Item Name: Crosstube Fwd

DART AEROSPACE LTD		Work Order:	
Description: Crosstube High Fwd (205/212/412)		Part Number:	D212-664-101
Inspection Dwg: D212-664-141 Rev: D			Page 1 of 1

DRAWING NO. D212-664-141	TITLE XTUBE ASSY (205/212/412 HI FWD)	REV. D	DART AEROSPACE LTD ENGINEERING ORDER		D.E.O. NO. D212-664-141-D-1	SHEET NO. SHEET 1 OF 2	SCALE NTS
DRAWN	CHECKED	MP	MFG. APPR.	ER	APPROVED	MP	DE APPR.
DATE 11.04.07	DATE 11.07.11		DATE 11.04.12		DATE 11/04/12		DATE 11.04.12

DRAWING NO. D212-664-141	TITLE CROSSTUBE ASS'Y (205 HI FWD)	REV. D	DART AEROSPACE LTD ENGINEERING ORDER		D.E.O. NO. D212-664-141-D-2	SHEET NO. SHEET 1 OF 1	SCALE NTS
DRAWN <i>IP</i>	CHECKED <i>ASS</i>	MFG. APPR. <i>IP</i>	APPROVED <i>MD</i>		DE APPR. <i>MD</i>		
DATE 11.07.15	DATE 11.07.20	DATE 11.07.21	DATE 11/07/21		DATE 11.07.21

**D212-664-141/-141B
ASSEMBLY DETAIL**

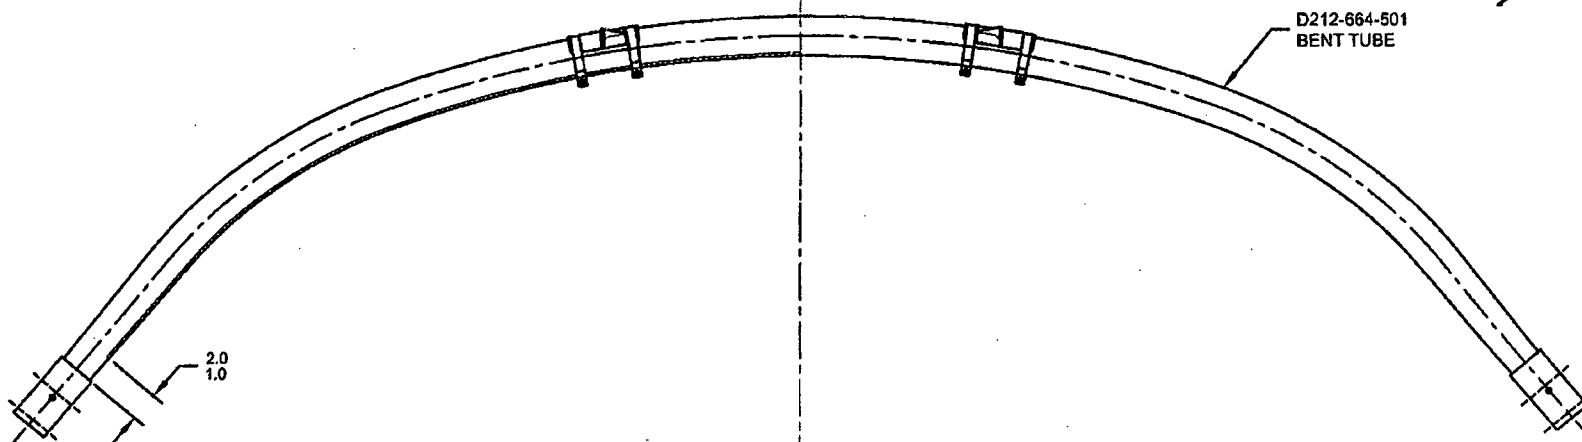
ADD AN INSPECTION WINDOW TO UNDERSIDE OF CROSSTUBE.

NOTES 2 OF SHEET 1 IS AMENDED AS FOLLOWS:

MASK AREA PRIOR TO PAINTING,
REMOVE MASKING AFTER PAINT
AND APPLY CLEAR COAT

- 2) FINISH: CHEMICAL CONVERSION COAT PER DART QSI 005 4.1
PRIME INSIDE AND OUTSIDE PER DART QSI 005 4.2
MASK UNDERSIDE OF CROSSTUBE AS SHOWN (HATCHED AREA) AND
PAINT OUTSIDE PER DART QSI 005 4.2
REMOVE MASKING AND APPLY CLEAR COAT
